RE: CHANGE ORDER NO. 1  
MONTZ PUMP STATION NO. 1 (PROJECT NO. P210301)

### CHANGE ORDER

No. 01

Project: Montz Pump Station No. 1

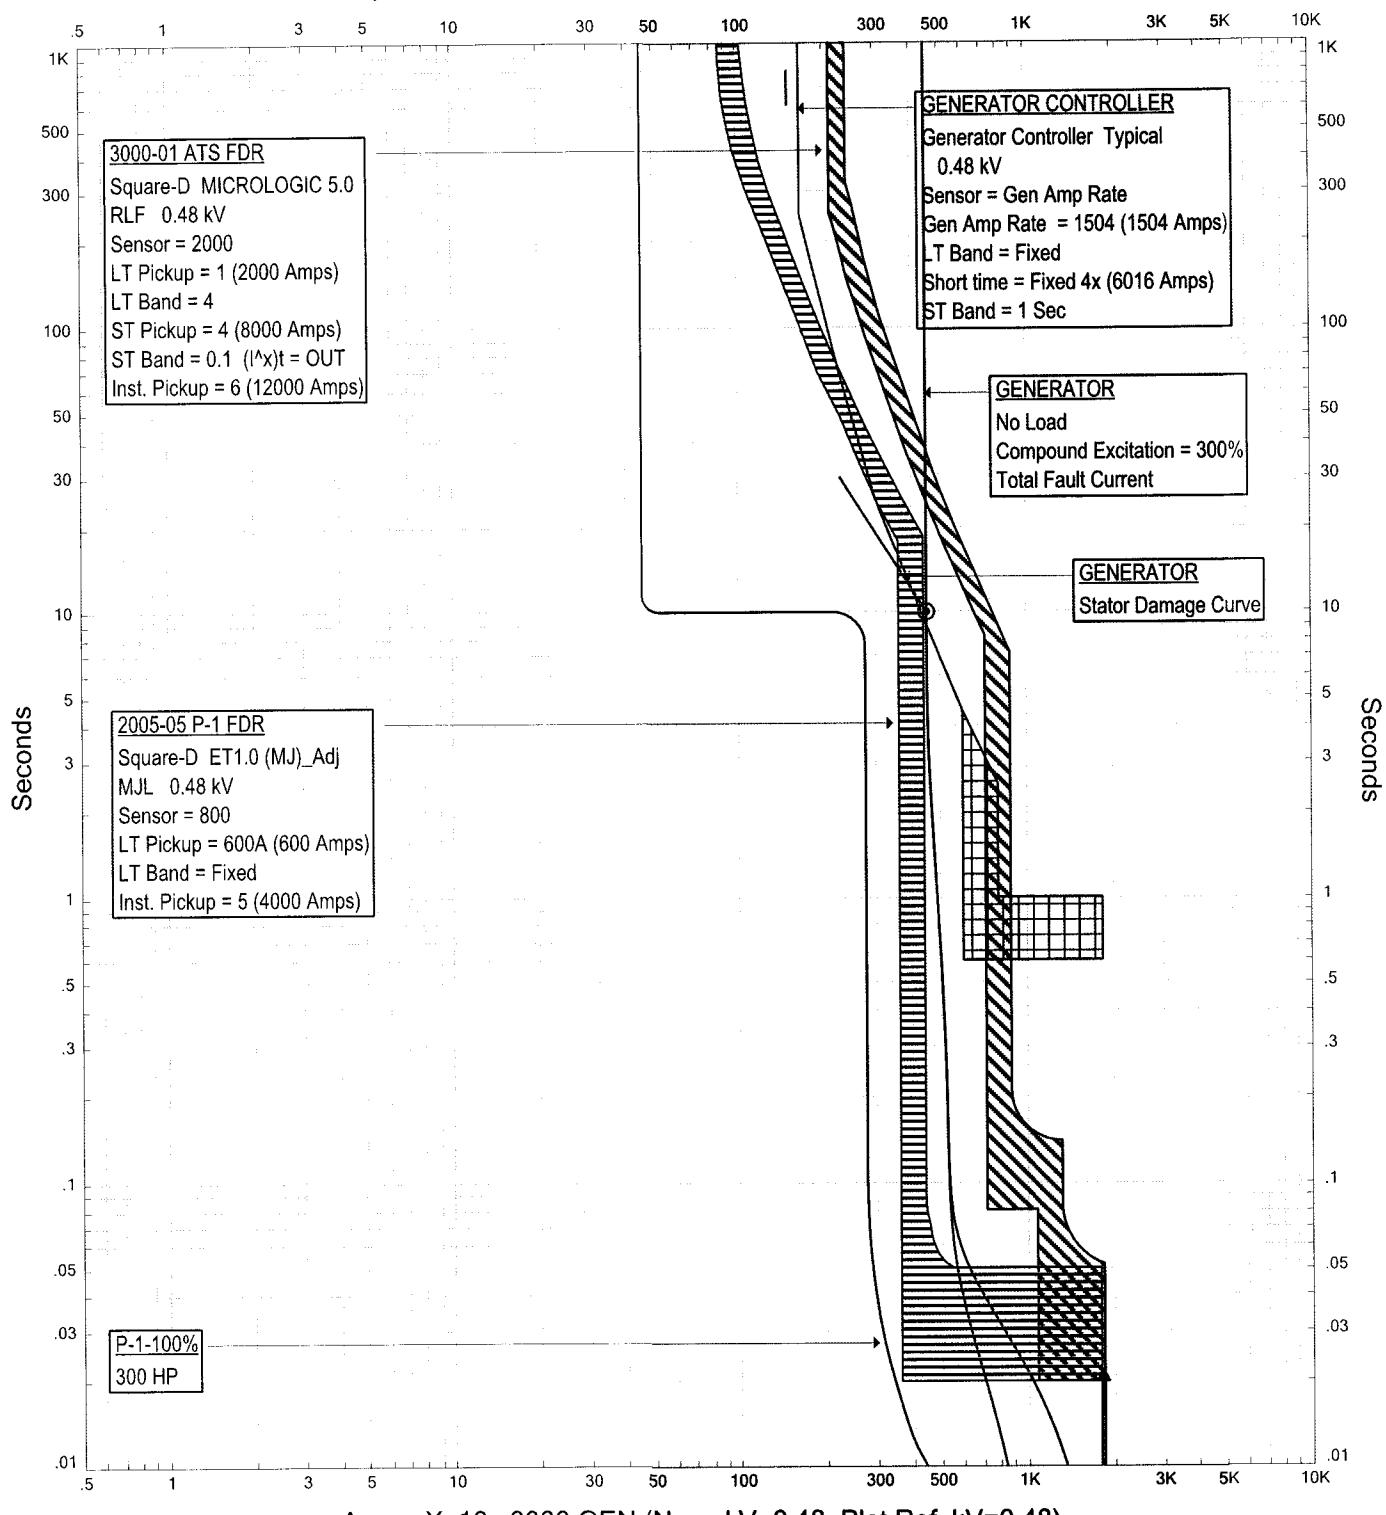
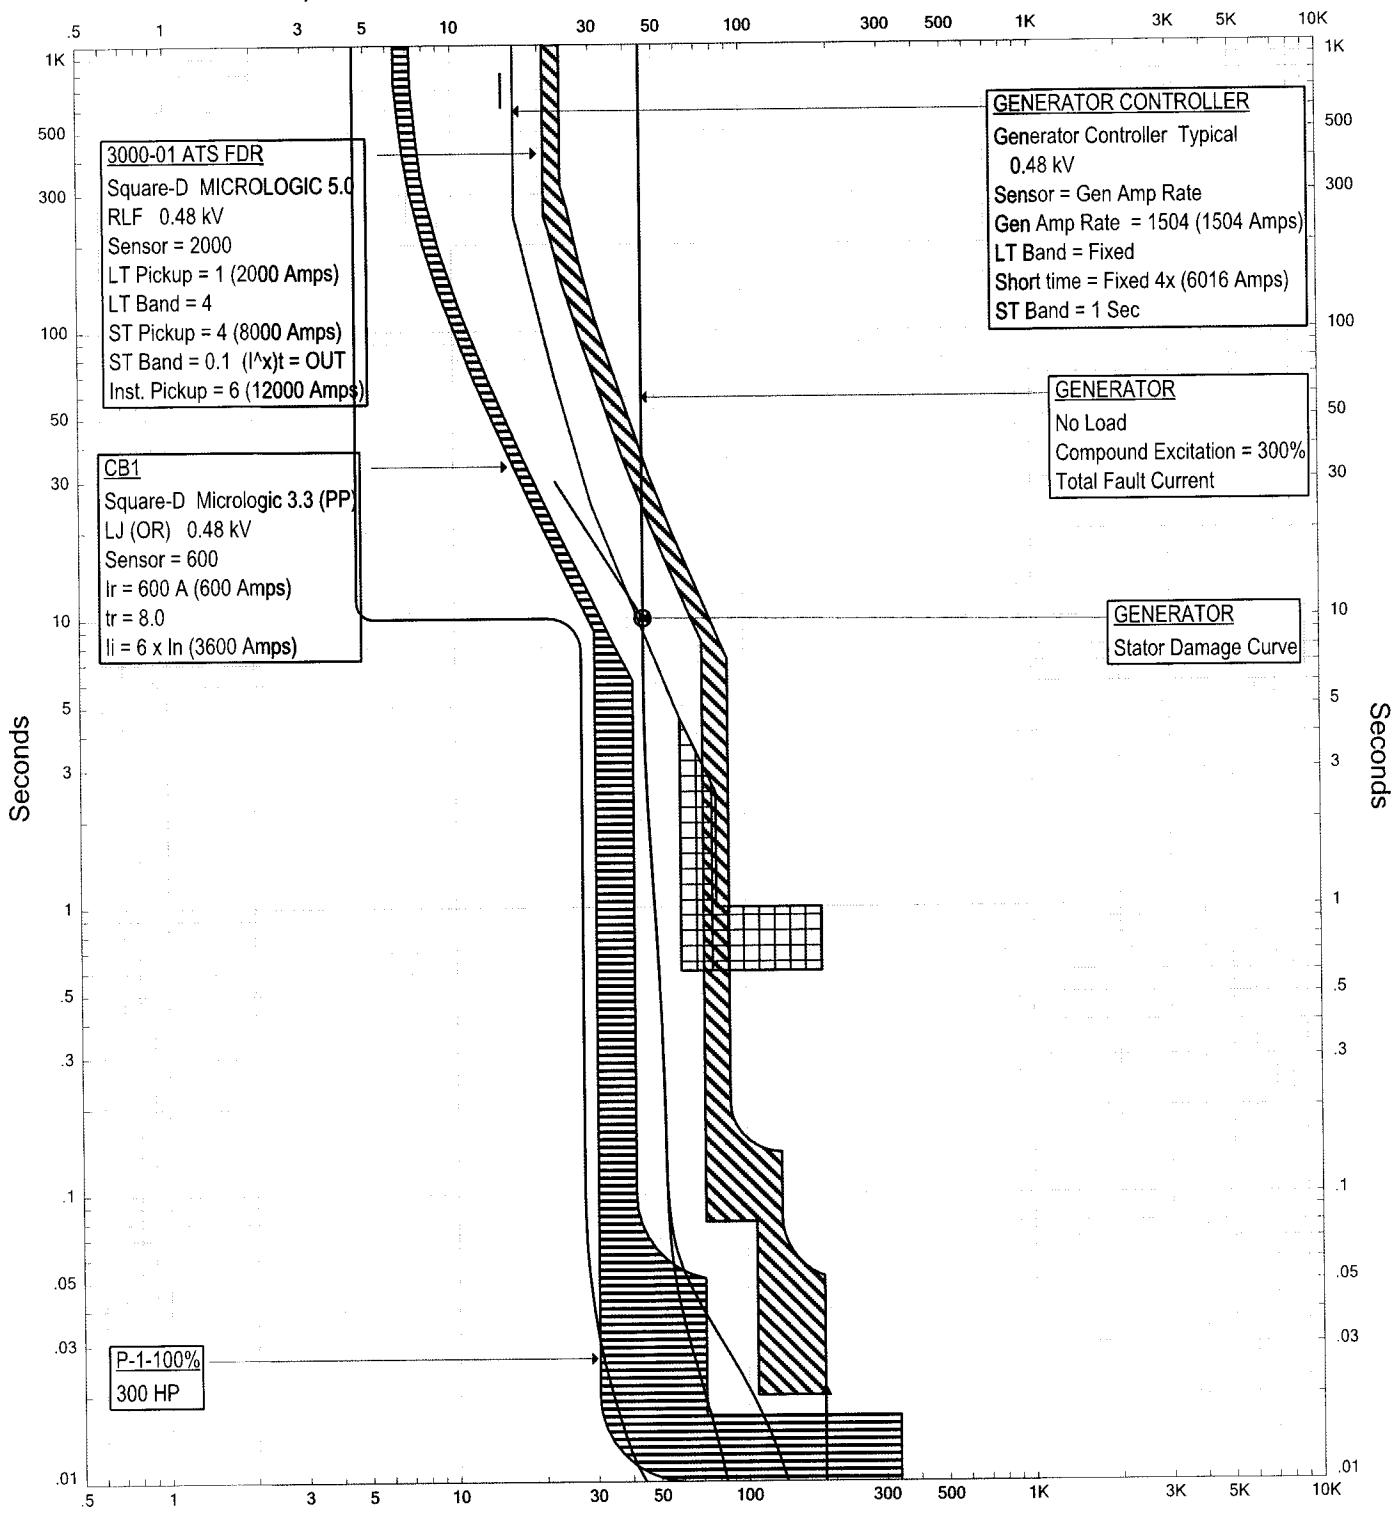
Revise the four (4) pump soft starter breakers from M-frame to L-frame breakers to add the adjustable time delay function necessary for proper coordination with the main generator breaker. The generator breaker is outside of SqD's scope and therefore coordination could not be confirmed prior to the bid.

The initial coordination study included M-frame breakers that meet the MCC specification (see below & attached), but the revised study requires additional functionality beyond what was specified to achieve proper coordination.

Our MCC for this project was quoted with “soft starts” that included our “standard” UL rated thermal-magnetic M-frame MCCB. Due to coordination study factors that were out of Schneider Electric’s control, The study findings requested we change the “standard” UL rated M-frame soft start breaker to a “LJ” electronic trip “LI” breaker to meet the current coordination study needs. We contacted our plant to verify if the “LJ” breaker would still comply with the UL rating of the soft start, which they verified it would. This change of breaker request has resulted in our change order #4. Please let me know if you have any other questions or concerns.

Sealevel Construction is pleased to submit, for your consideration, a lump sum proposal in the amount of **\$13,859.31** to revise the four (4) pump soft starter breakers from M-frame to L-frame breakers to add the adjustable time delay function necessary for proper coordination with the main generator breaker.
